Subject: Duke Energy Corporation
Catawba Nuclear Station, Units 1 and 2
Docket Numbers 50-413 and 50-414
Request for Relief Number 04-CN-001
Reply to Request for Additional Information

REQUEST FOR ADDITIONAL INFORMATION

The U. S. Nuclear Regulatory Commission (NRC) staff has reviewed the licensee's submittal dated February 19, 2004, regarding a request for relief associated with Category B-J full penetration welds of nozzles in vessels, branch connection welds, nominal pipe size 4 or larger. The NRC staff has identified the following information that is needed to enable the continuation of its review.

Figure 1 Cross-section Typical Branch Connection

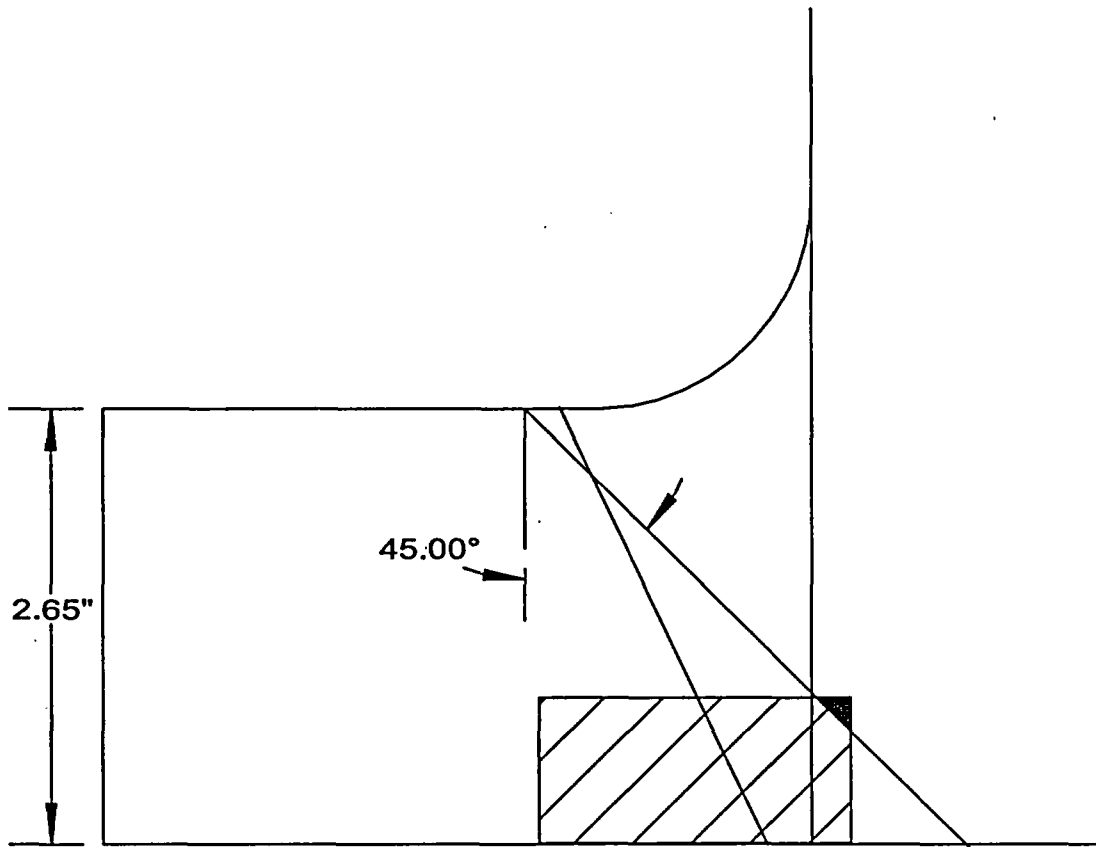
4. On page 2 of the submittal, you indicate that the subject welds were volumetrically examined during preservice and the first 10-year inservice inspection (ISI) interval. Discuss the coverage achieved, transducers used, ultrasonic testing (UT) technique (manual/automatic), and availability of the actual data from the inspections. Describe the conditions that exist that have rendered UT ineffective for the second 10-year interval.

ASME Section XI, Appendix III paragraphs III-4420 requires coverage of the examination volume in two beam path directions. Paragraph III-4430 requires scanning over the weld crown in two opposing directions. The weld configuration as shown on the attached profile sketches, Figures 1, 2, and 3, only allows scanning from the main coolant loop side of the weld. The aggregate coverage achieved in 1993 was approximately 35% for each weld.

During preservice and inservice inspections for the first interval, ultrasonic examinations were performed using a manual, contact technique. The search units contained dual element, side by side, refracted longitudinal wave transducers having a frequency of 1.0 MHz, a refracted angle of 45 degrees and a focal depth of 2.5 inches. Transducer element shapes were square with a size of 1.0" x 1.0" and rectangular with a size of 0.75" x 1.0". Combinations of flat and contoured wedges were used to scan axially and

12" $\frac{7}{8}$ NOZZLE
DRAWING # 2

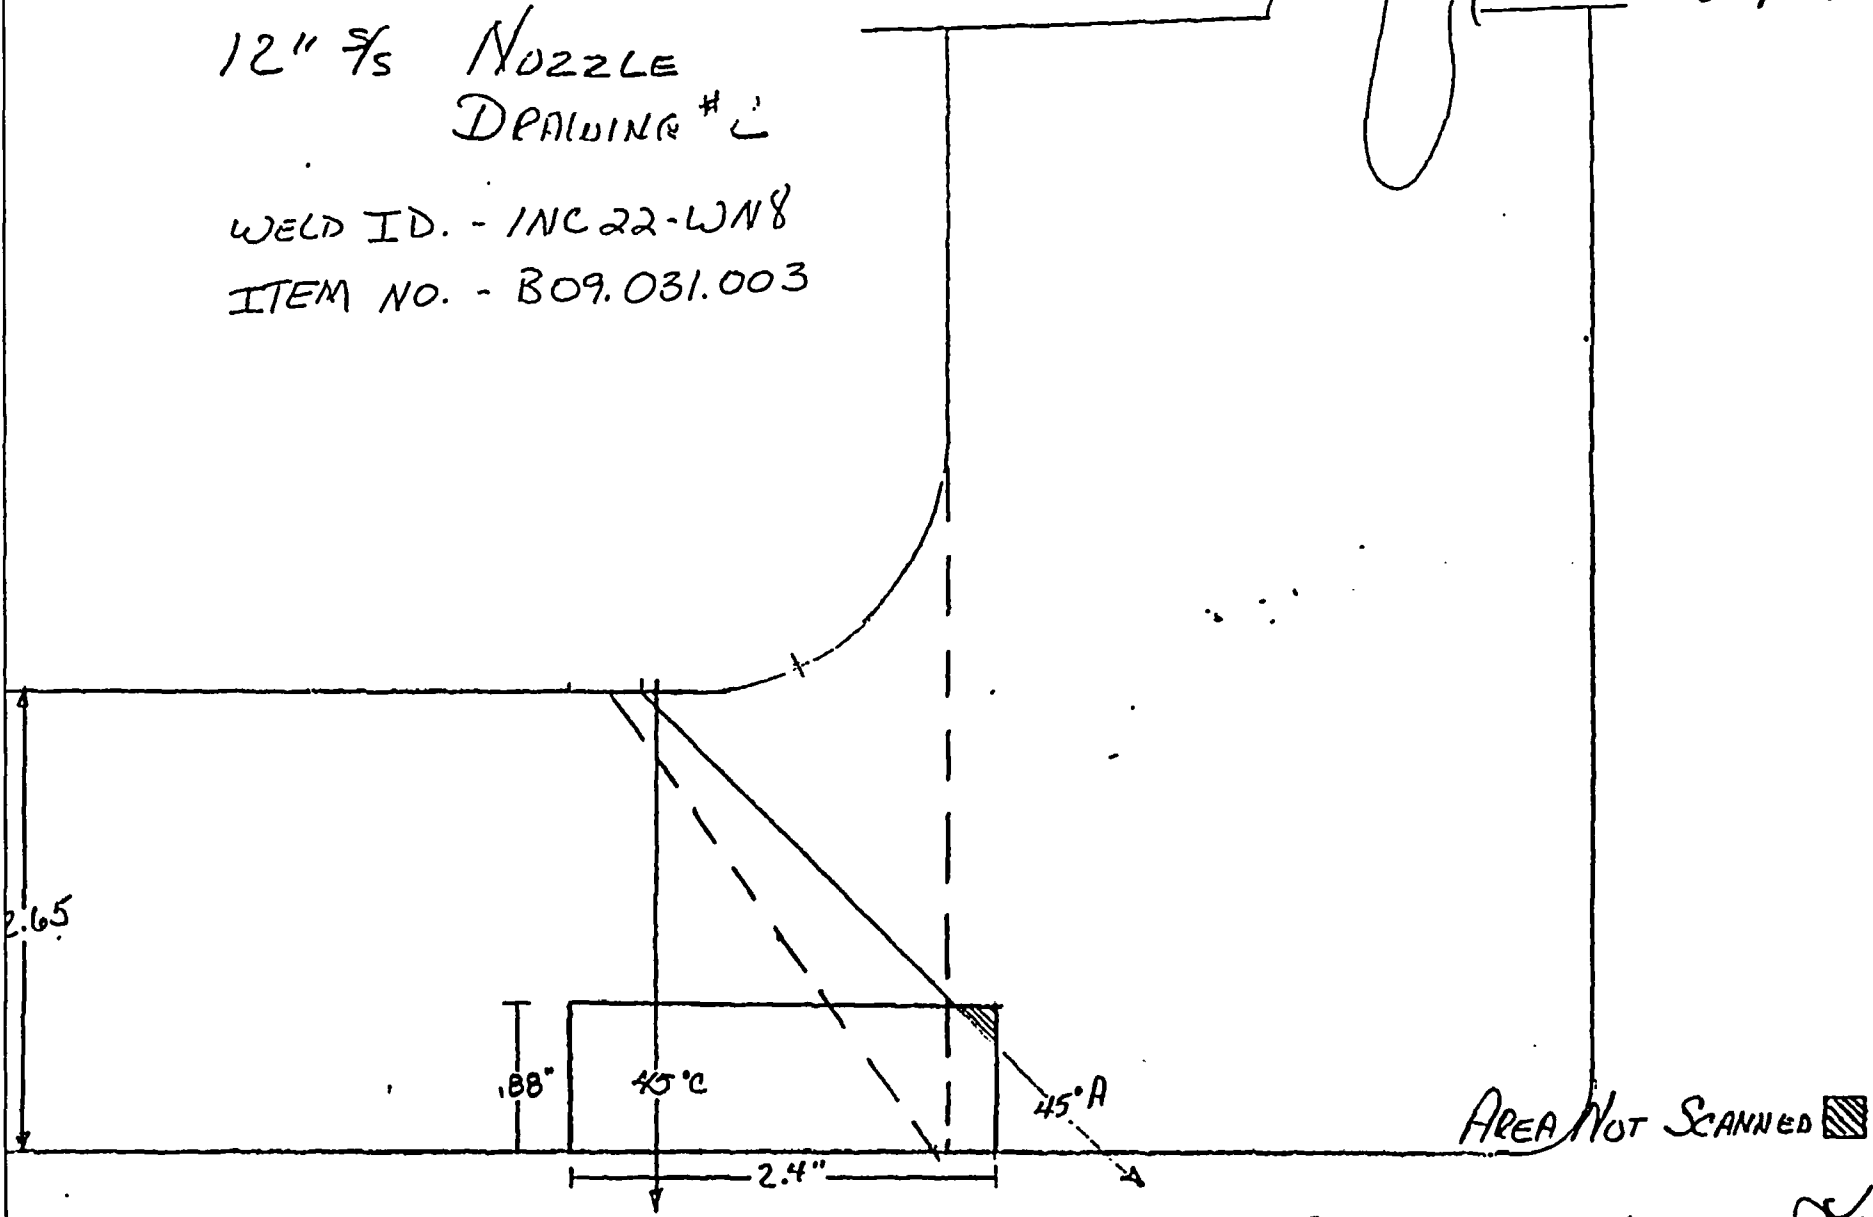
1. On page 2 of the submittal, you reference the nozzle to branch connection weld 1NC22-WN8, but no further information is provided. Please provide the non-destructive examination worksheets and associated figures for this weld.

WELD ID. - INC 22-WN8
ITEM NO. - B09.031.003
